STORMWATER MANAGEMENT COMMISSION

Meeting Minutes

Location: Brookside Subdivision, Unincorporated Gurnee, Lake County, IL

Topic: Resident concern about stormwater/changes to drainage within subdivision

Attachment 4

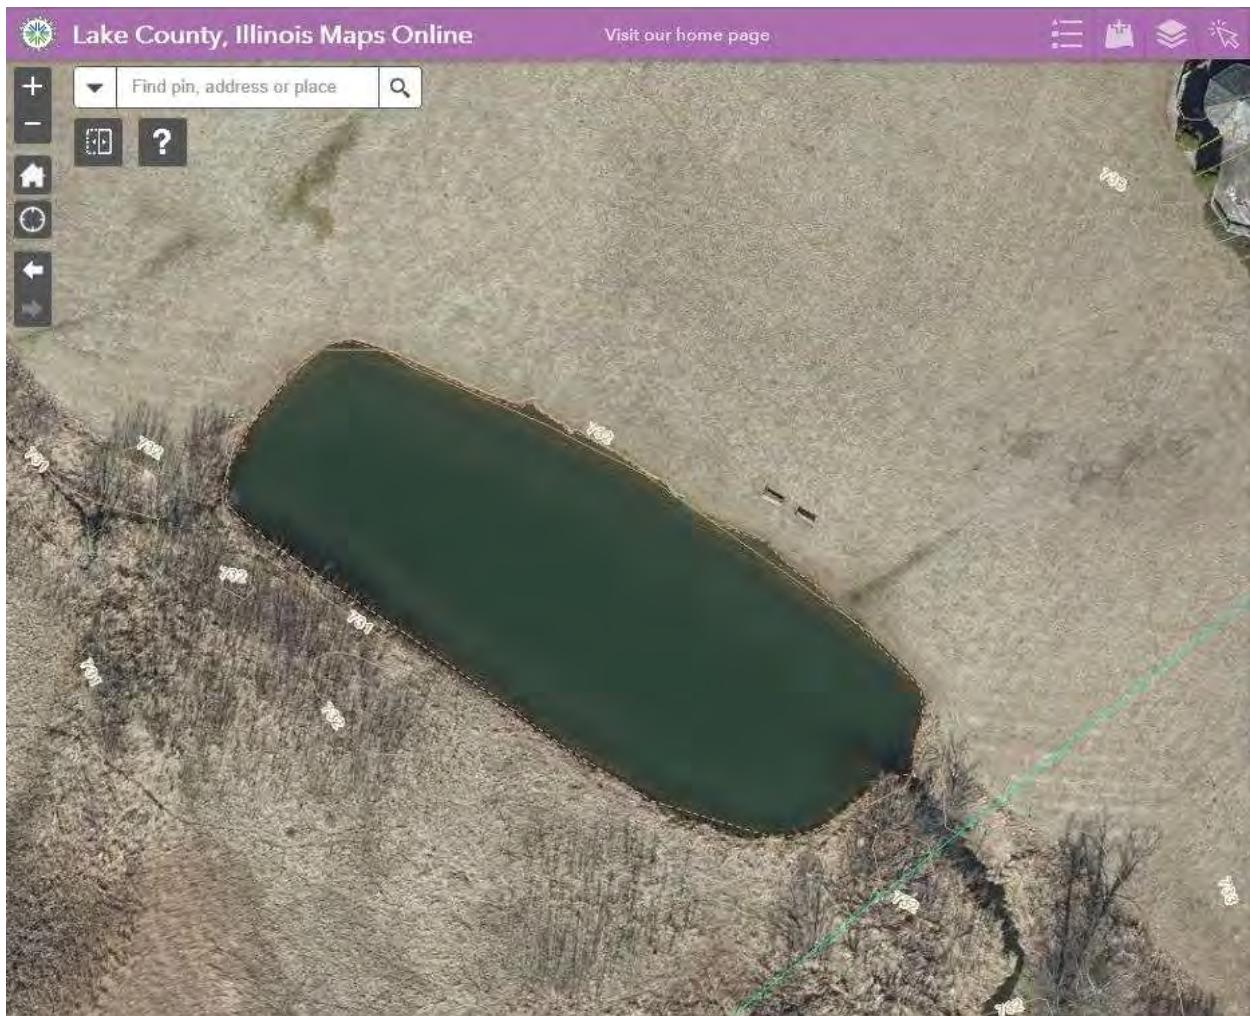
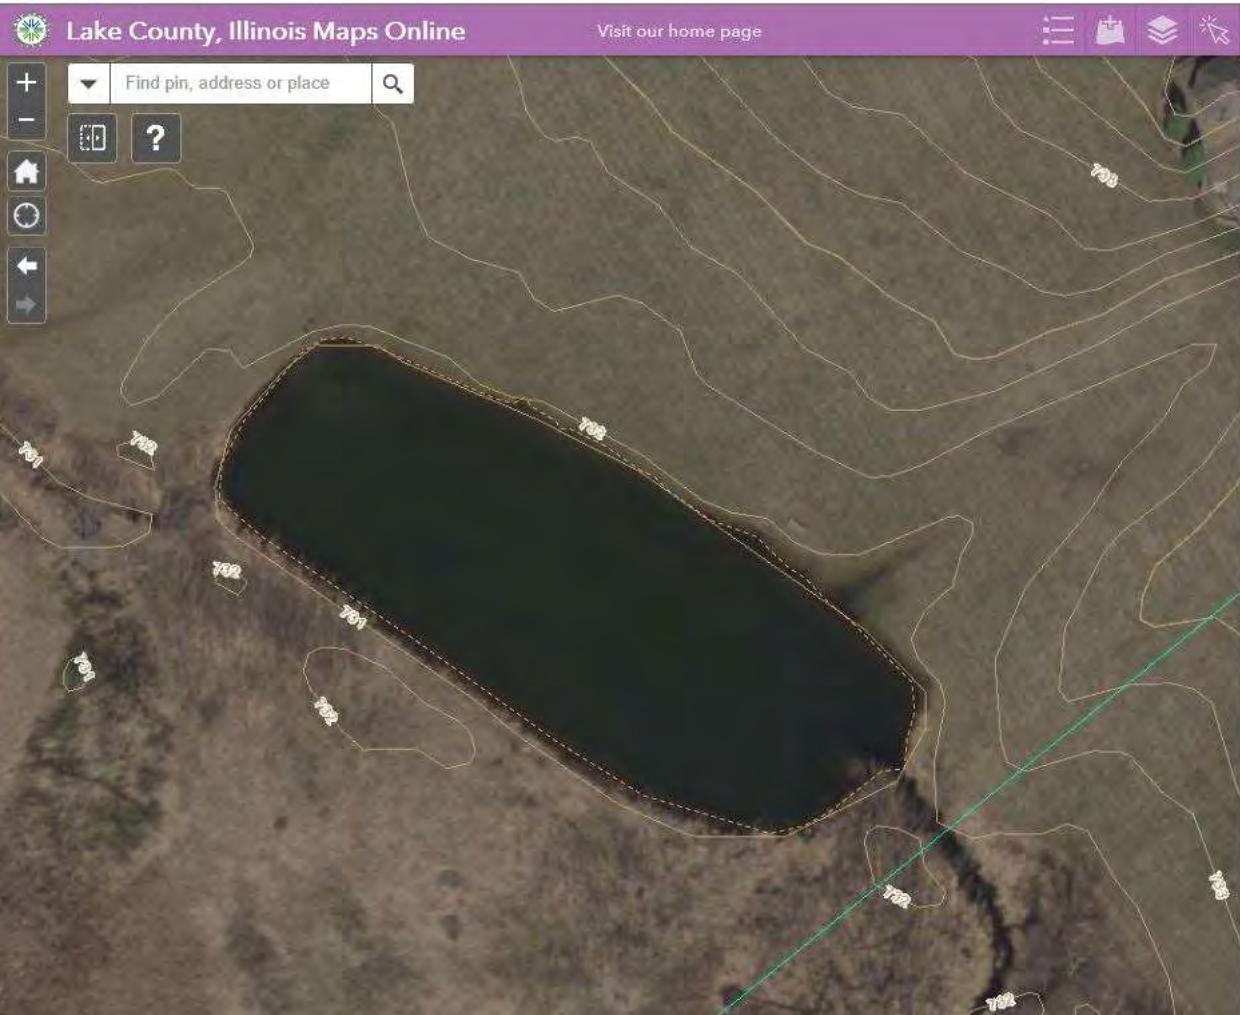
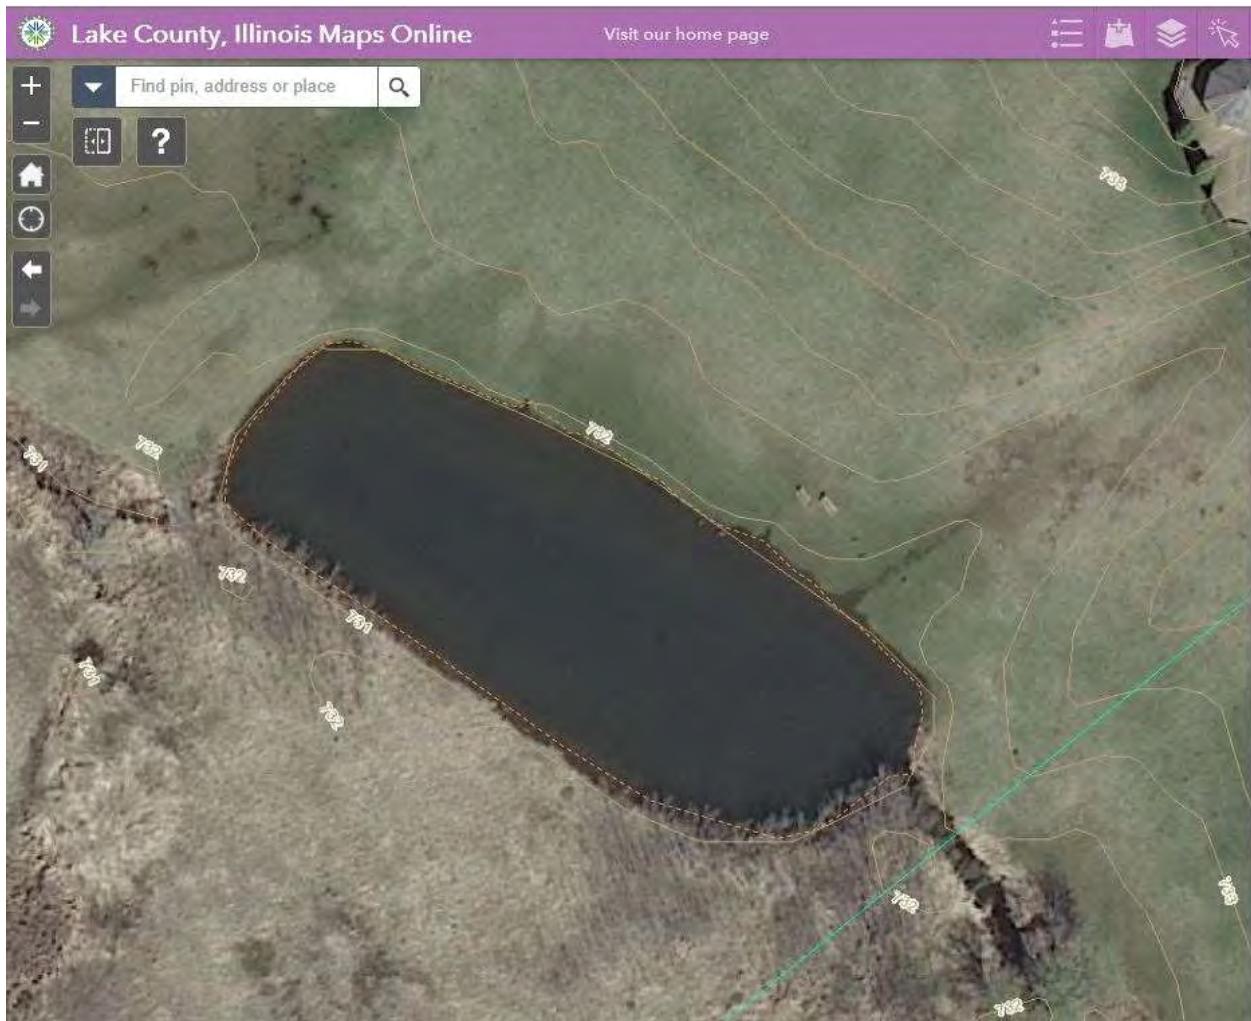
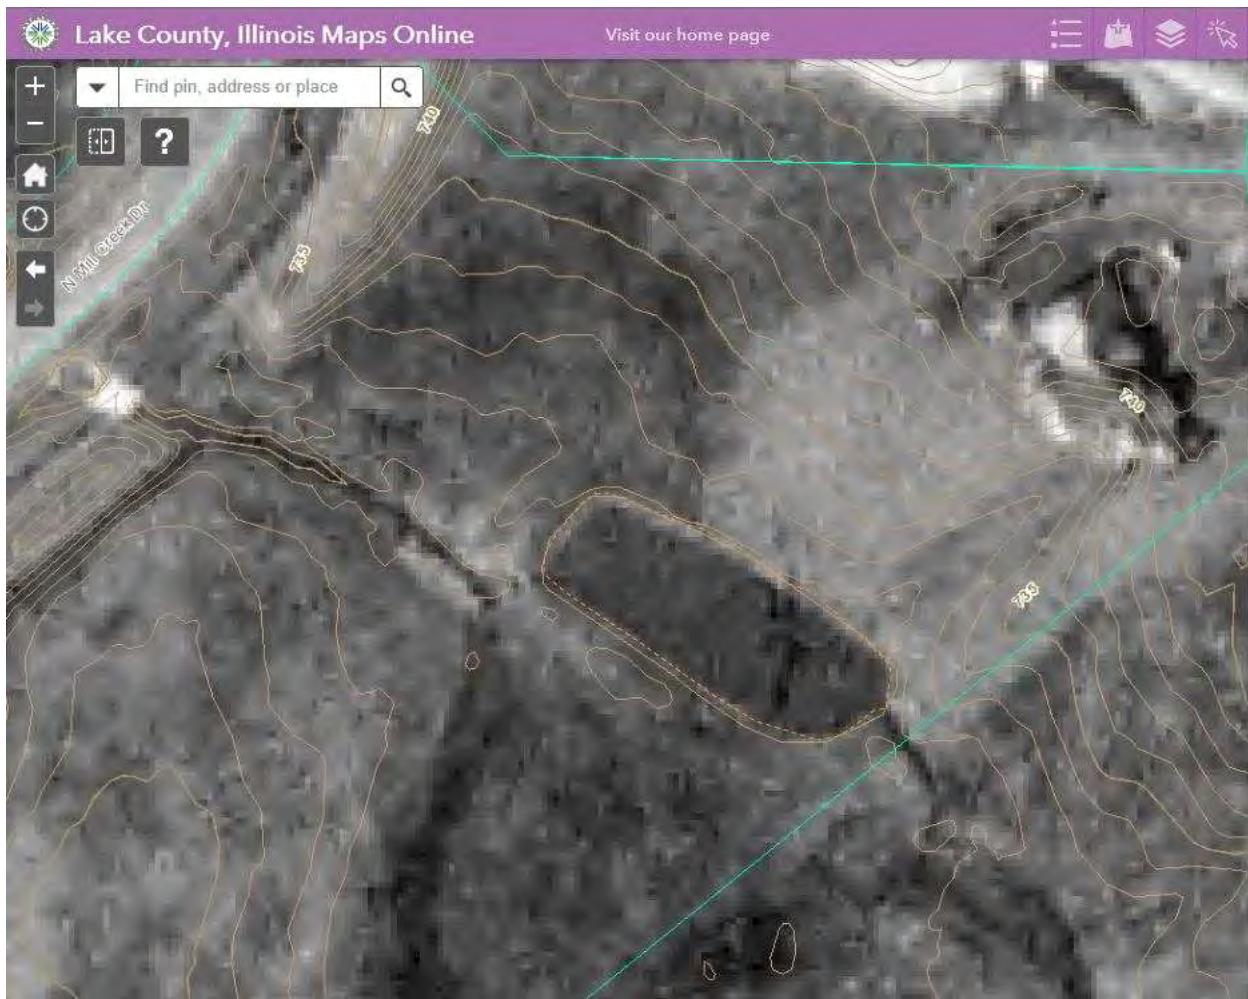
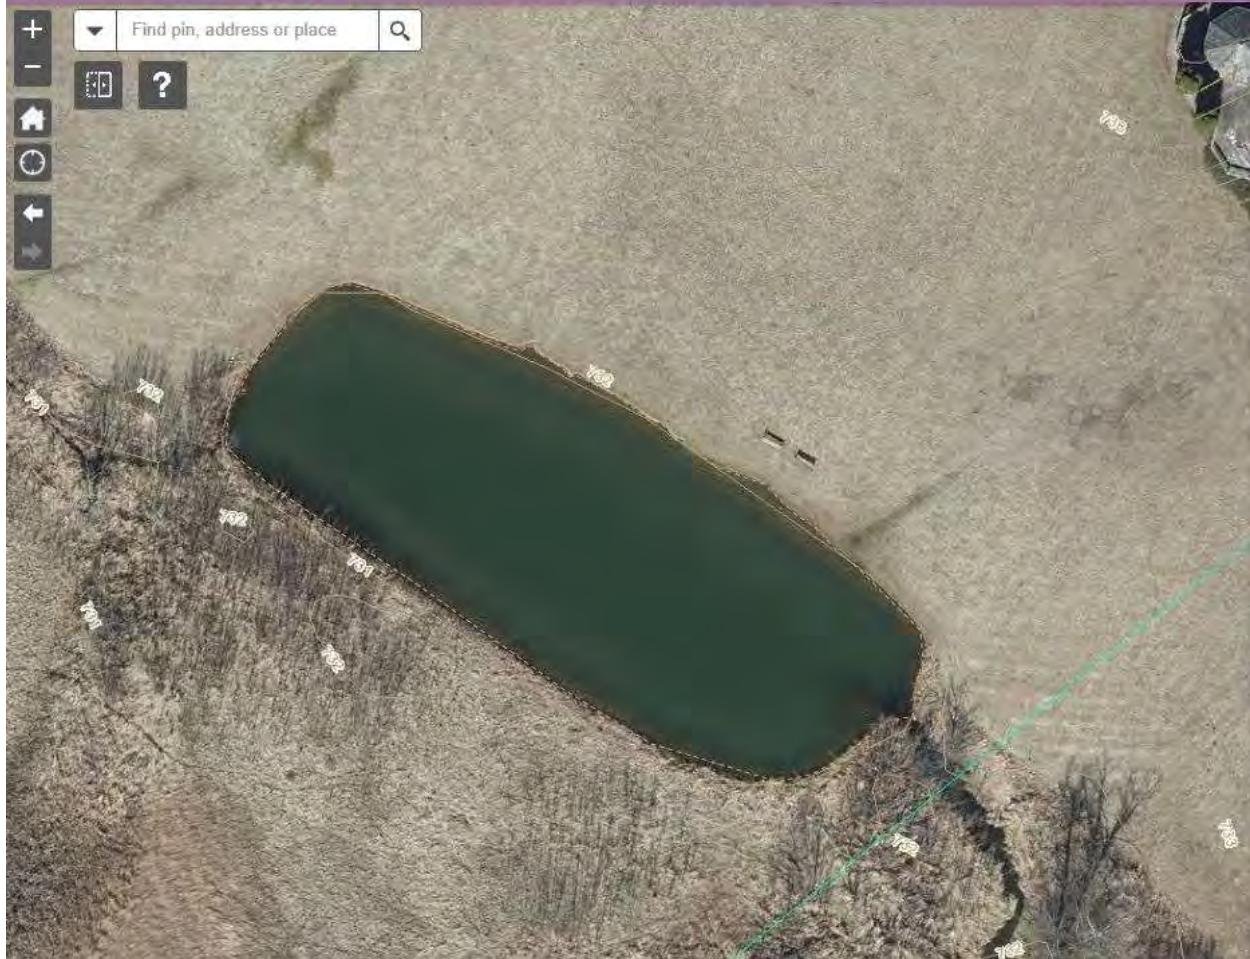
2018 pond limits aerial – See approximate shoreline highlighted with orange dashed line. Kept this line work for all years to see difference. -BLF

ACTION: PBD to review files and aerials to determine if the pond has been intentionally enlarged (there also should be permits on file from PBD & the US Army Corps for installing the rip rap and fabric). [PBD 4/20/20: Attachment 4 provides a series of aerials regarding Jim's (HOA) concern with the downstream pond in Hunt Club Farms. I do not see evidence that this pond is being held to a higher water surface elevation than in the past. I do notice that the turf grass side of this pond is experiencing erosion while the unmanicured side is holding in place.]

STORM LIFT STATION
N.T.S.

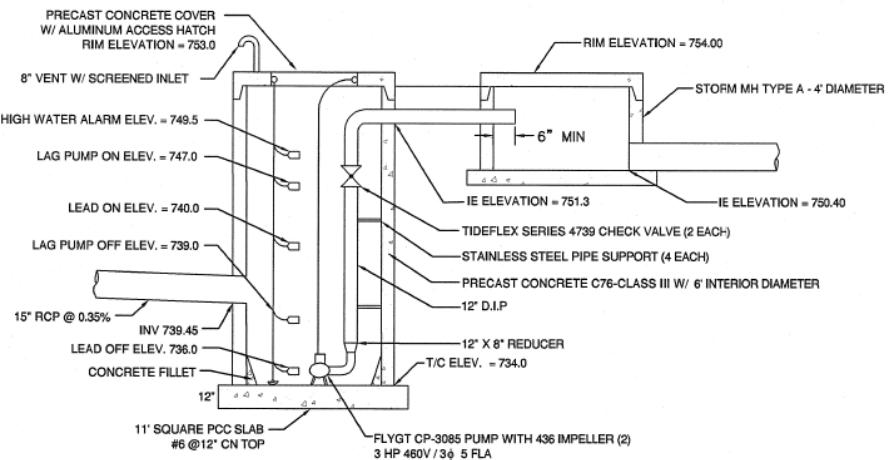
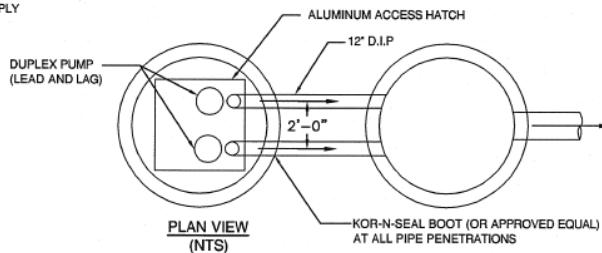
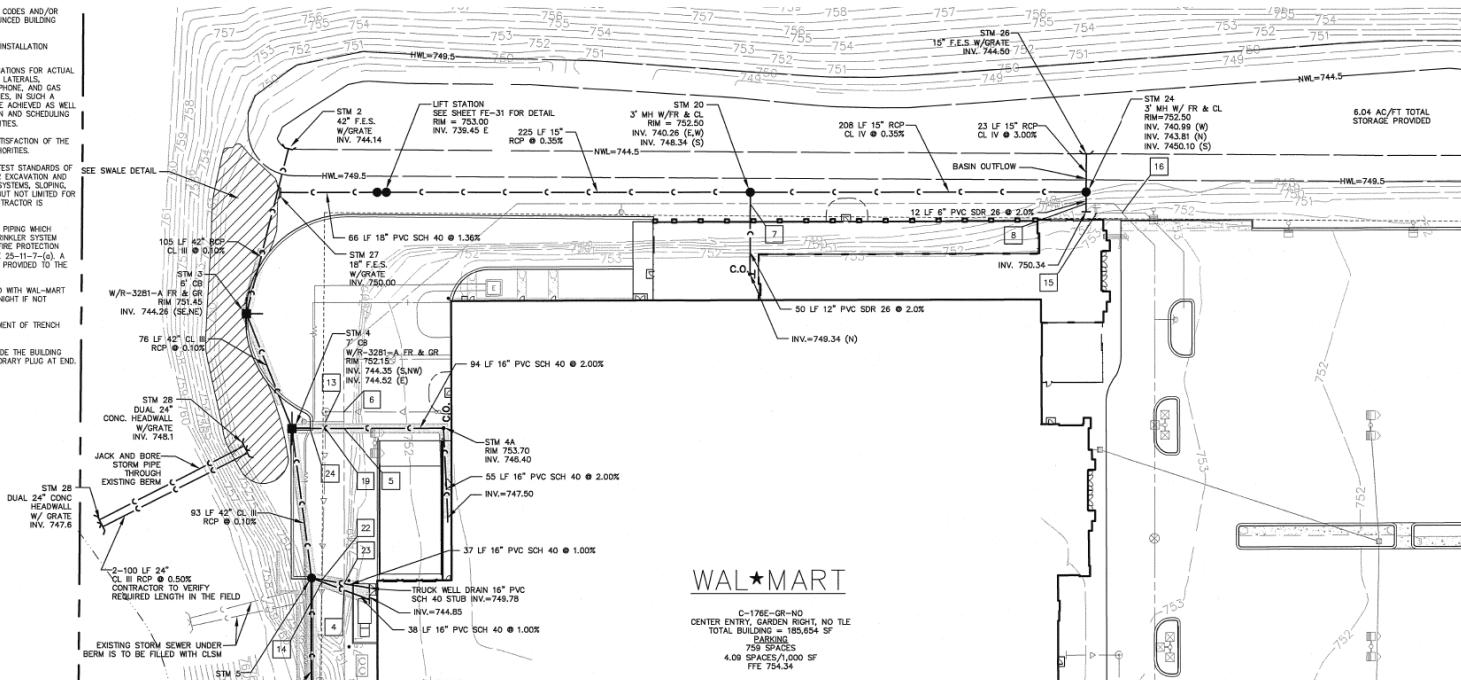
- a. Walmart (Gurnee) – The detention basin appears smaller. Is maintenance/ dredging needed to restore the stormwater storage volume at the basin? What are the maintenance requirements? Are they being followed/implemented? What is the operational procedure/requirement for the pump mechanism (e.g., when does it turn on and pull water out of the basin)?

- Are there rules concerning how often and when the pump is allowed to run?
- How often is the reduced size pond dredged?

ACTION: SMC will forward these questions/concerns to the Village of Gurnee (via these minutes) and facilitate disbursement of the Village's response. Note that Gurnee previously provided the following response to the concern about basin reconfiguration and apparent reduction in storage volume via 4/6/20 email, as modified in a 4/30/2020 email: [When Walmart expanded in 2008, they reconfigured their stormwater basin. The new wet bottom design incorporated a pump system allowing the normal water level to be below the outfall resulting in additional bounce in the basin and the requisite needed amount of storage volume (Attachment 6). Even though the footprint was decreased, the amount of storage volume was increased. Current basin storage volume is 6.04 ac-ft. The pump system is designed to kick on when water starts to flow out of the basin at elevation 744.50. A single pump run will discharge at 1.3 cfs out through an 18" storm sewer into a vegetated swale at elevation 750.00. From that point, the water travels south to twin 24" culverts (that serve as the emergency overflow route) through the berm at elevation 748.1 and travels into the Grandwood Park wetland complex. A two-pump run is designed to trigger at elevation 747.0 and will double the output of the pump system to 2.6 cfs. The Village of Gurnee performs annual inspections of the stormwater systems at all sites in the village to verify that proper maintenance is being performed. The Walmart basin is currently in compliance.]
